Jayne Harkins  
Attention BCOO-4600  
Bureau of Reclamation  
P.O. Box 61470  
Boulder City, NV 49006-1470**Re: Draft Environmental Impact Statement ("Draft EIS or DEIS") on the Colorado  
River Interim Surplus Criteria**

TEN TRIBES PARTNERSHIP COMMENTS  
COLORADO RIVER INTERIM SURPLUS CRITERIA  
DRAFT ENVIRONMENTAL IMPACT STATEMENT

**Table 1.** Potential Economic Disincentive to Tribal Water Development (\$million/year).

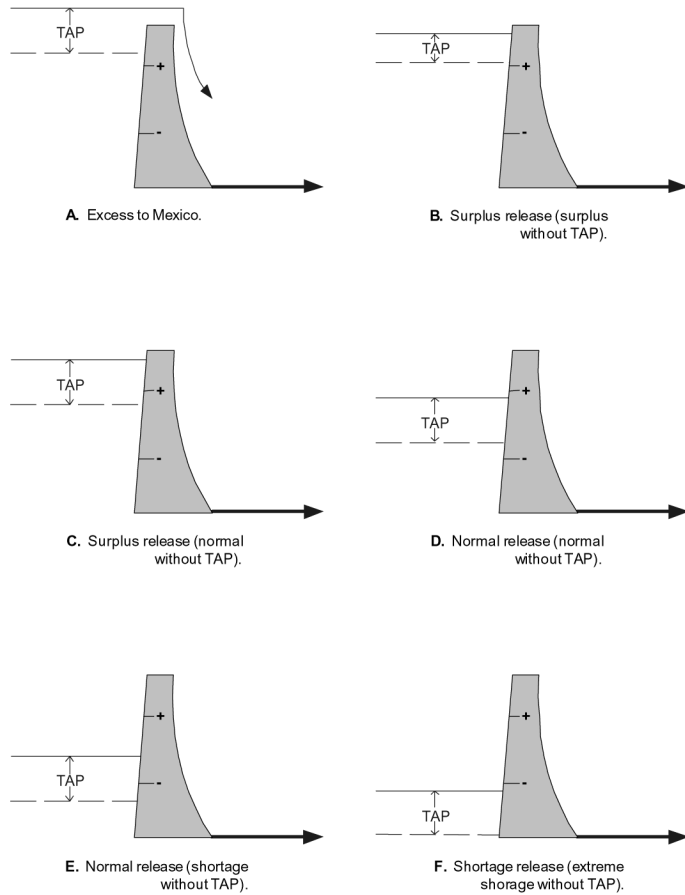
TAP releases are valued at \$435/af, and shortage relief TAP releases at \$580/af. Table 1 gives the results of assigning these values to the implicitly used Upper and Lower Basin undeveloped Tribal waters. The amounts shown represent the 60-year annual average value of the Tribal water that will be used by the Lower Basin non-Indians under the various alternatives. It may be considered a disincentive to the development of Tribal water as those using this water would have to replace it at the approximate values shown, thereby providing this level of disincentive to others to allow for development of the water on Tribal lands. From Table 1 the No Action Alternative results in the lowest economic disincentive to Tribal water development.

22: The Department does not believe that the proposed action will serve as a disincentive to Indian water development. See response to Comment 53-6.

**Figure 1.** Different combinations of Tribal Accounting Pool (TAP) and contents of Lake Mead relative to surplus (+) and shortage (-) trigger elevations.

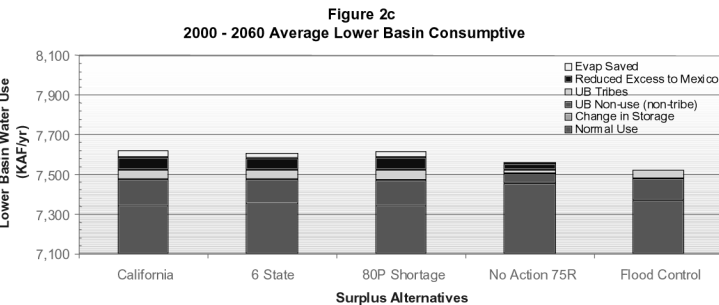
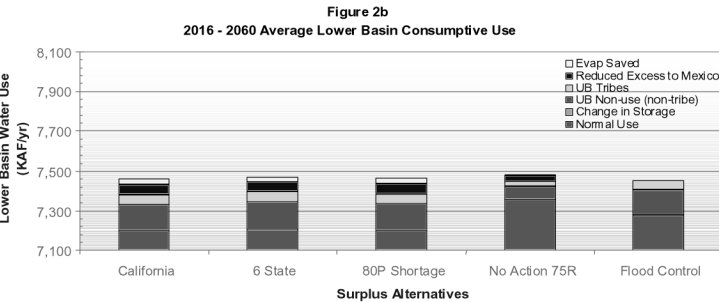
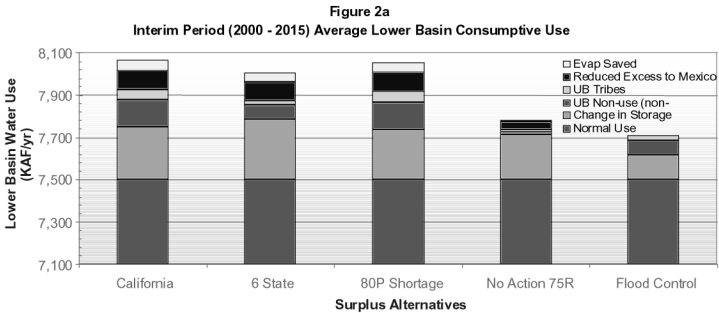
Figure 1 shows various storage conditions in Lake Mead relative to surplus (+) and shortage (-) trigger elevations.

- a) Under the condition shown in Figure 1a excess water would be delivered to Mexico and TAP would be reduced by the amount of excess. If the excess to Mexico exceeds the amount in TAP, TAP contents would be zeroed. The sharing of impact with top water banks discussed above would apply to this condition.
- b) The condition shown in Figure 1b would result in a surplus delivery with or without TAP and no water would be withdrawn from TAP.
- c) Under the condition shown in Figure 1c a surplus would be declared. Without TAP a normal release (no surplus) would be declared. Because it is the contents of TAP that put the lake level above the surplus trigger elevation and allow a surplus to be declared, an amount equal to the lesser of the surplus and TAP contents would be added to the tally of surplus water resulting from the undeveloped Lower Basin Tribal water and withdrawn from TAP.

- d) The condition shown in Figure 1d would result in a normal delivery with or without TAP and no water would be withdrawn from TAP.
- e) Under the condition shown in Figure 1e a normal delivery would be declared. Without TAP shortage would occur. Since it is the contents of TAP that put the lake level above the shortage trigger elevation and allow normal delivery rather than shortage, an amount equal to the lesser of TAP and the difference between normal and shortage deliveries would be added to the tally of normal water (shortage relief) resulting from the undeveloped Lower Basin Tribal water and withdrawn from TAP.

- f) Under the condition shown in Figure 1f shortage occurs with or without TAP water; however, to the extent that releases are greater with TAP water than without, the difference would be added to the tally of shortage reduction attributed to the undeveloped Lower Basin Tribal water and withdrawn from TAP.

Figure 3a shows a relatively large amount (nearly 80 KAF annually) of TAP water going to realize surplus deliveries (TAP condition shown in Figure 1c) under the California, Six State, and Shortage Protection Alternatives and a modest amount (17 KAF annually under the No Action Alternative during the interim period. Small amounts of TAP water also go to normal (TAP condition shown in Figure 1e) and extreme shortage relief (TAP condition shown in Figure 1f).

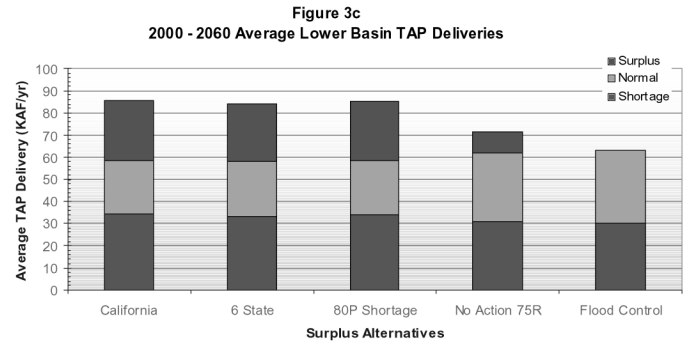
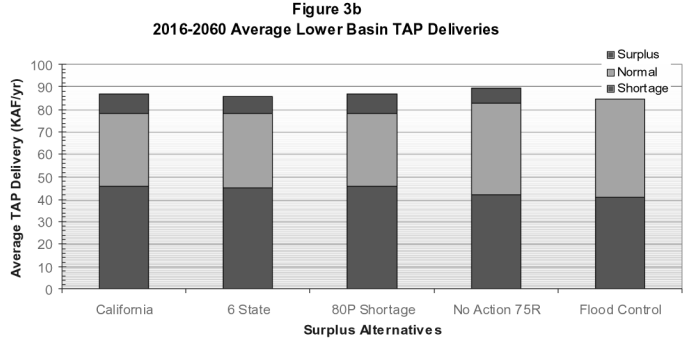
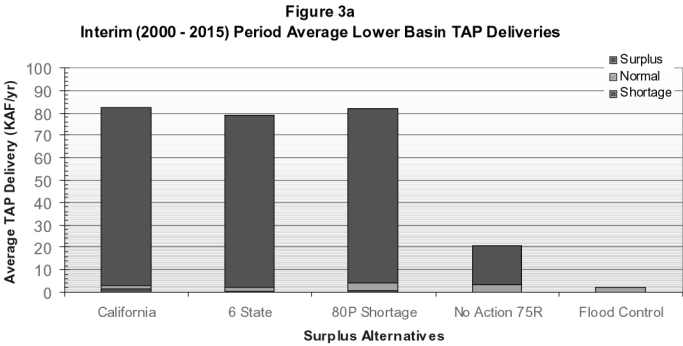
Figure 2a shows that the storage drawdown in Lakes Powell and Mead is the largest source of surplus water to the Lower Basin for all surplus alternatives during the interim period (2000-2015). With the exception of the No Action Alternative, undeveloped water in the Upper Basin is the next largest source of Lower Basin surplus, followed by reduction in spills (excess to Mexico), and then reduced evaporation loss due to the lowering Lakes Powell and Mead.

For the post-interim period (2016-2060), Figure 2b, the average Lower Basin consumptive use is below 7.5 MAF and there is no surplus resulting from change in storage in Lakes Mead and Powell as these reservoirs were effectively drawn down during the interim period. The No Action Alternative produces the greatest Lower Basin consumptive use during the post-interim period and with less than half the dependency on undeveloped Upper Basin water as the other alternatives.

Figure 2c shows the annual averages over the entire 60-year modeling period. Because the change in storage over the entire modeling period is practically the same for all alternatives it does not figure in to a 60-year average comparison of the alternatives. Figure 2c as well demonstrates that the No Action Alternative has the least reliance on undeveloped Upper Basin water of all the alternatives.

Figures 3a-c provide an analysis, using a top-water accounting method in Lake Mead, of the implicit use of undeveloped Lower Basin Indian water rights by non-Partnership entities. As mentioned earlier, the Lower Basin currently exceeds its 7.5 MAF apportionment despite underdevelopment of Lower Basin Tribal waters rights. Thus the undeveloped Lower Basin Tribal water rights are a basic component of Lower Basin non-Indian use. The Partnership believes that the implicit use of its undeveloped Lower Basin water can best be analyzed through water accounting methods described earlier. For this analysis the Partnership assumed that on average 155 KAF was deposited in the Tribal Accounting Pool (TAP) each year. The 155 KAF is the average undeveloped

Figure 3c shows the 60-year average TAP releases. From this figure it is apparent that there is little difference among the liberal criteria (California, Six State, and Shortage Protection Alternatives) with respect to TAP releases and hence to the implicit reliance on undeveloped Lower Basin Tribal waters. The No Action and Flood Control Alternatives have moderately lower 60-year average TAP releases than the three liberal interim criteria.

21: See response to Comment No. 71-16. See also Attachment Q which shows the Ten Tribe depletions and diversions that were used in the FEIS alternatives.
